# Access Compliance Report

## Public Rights-of-Way

### (Curb Ramps)

Intersection ID: 49399	Main Street: CHILFORD_CT	Cross Street: HEREFORD_ST	Location: SW
ADA ID: B6131439218F	Ramp Type: PerpDiag	Initial Pass/Fail: Fail	Overall Compliance: No
Codes/Mitigation Info/Possible Solution		Field Measurements/Component Compliance	
Severity Score: 10

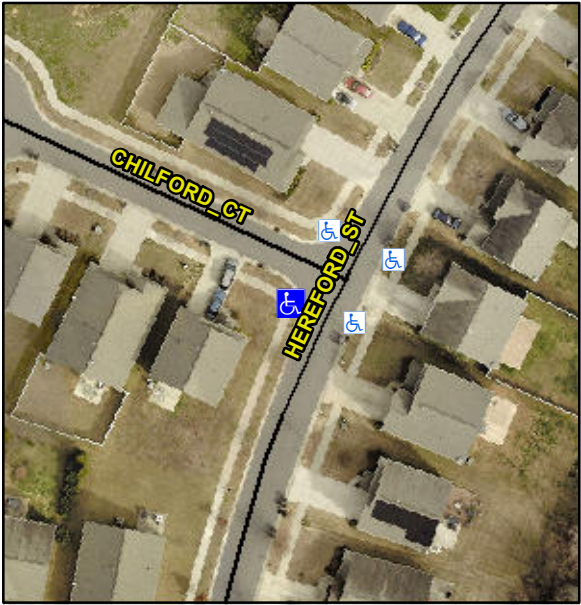
Possible Solutions:		Compliance		Description		Data	Compliance	Description	Data
	Remove & Replace Curb Ramp With Two New Directional Ramps or Equivalent.		N/A		Ramp Length (in)		74.0	Yes	Ramp Slope (%)	7.6
<p>Surveyor Notes:</p> <p>N/A</p>			No		Ramp Width (in)		47.5	No	Ramp XSlope (%)	4.7
			N/A		Flare Type LT		N/A	N/A	Flare Type RT	N/A
<p>PROW/ADA:</p> <p>Not Found, R304.5.1, R304.5.3</p>			N/A		Flare Slope LT (%)		N/A	N/A	Flare Slope RT (%)	N/A
			N/A		Flare Traversable LT?		N/A	N/A	Flare Traversable RT?	N/A
<p>Total Cost:</p> <p>\$ 3200.00</p>			N/A		Landing Length (in)		N/A	N/A	DWS Provided?	N/A
			N/A		Landing Width (in)		N/A	N/A	DWS Contrast?	N/A
			N/A		Landing Slope (%)		N/A	N/A	DWS Length (in)	N/A
			N/A		Landing X Slope (%)		N/A	N/A	DWS Full Width?	N/A
			N/A		Landing Curb? (Y/N)		N/A	N/A	DWS Offset (in)	N/A
			N/A		Shared Landing?		N/A			
			N/A		Gutter Ponding?		N/A	N/A	Gutter Slope (%)	N/A

N/A		Gutter Lip Ht (in)		N/A	N/A	Gutter X Slope (%)	N/A
			N/A		Painted X Walk1?		No	N/A	Painted X Walk2?	No
					X Walk 1 Direction		To SE		X Walk 2 Direction	To NE
			N/A		X Walk 1 Width (in)		N/A	N/A	X Walk 2 Width (in)	N/A
					X Walk 1 Slope (%)		1.3		X Walk 2 Slope (%)	1.6
					X Walk 1 X Slope (%)		2.1		X Walk 2 X Slope (%)	2.8
			N/A		Ramp inside XWalk1?		N/A	N/A	Ramp inside XWalk2?	N/A
					Road Slope (%)		3.9	N/A	Clear Space?	N/A
					Road X Slope (%)		2.2	N/A	Clear Space to XWalk (in)	N/A
			N/A		Any Obstructions?		N/A	N/A	Storm Grate/Utility Hazard?	N/A
					Obstruction Type				Storm Grate/Utility Type	
								N/A		N/A
								Yes	Surface Condition? (G/P)	Good
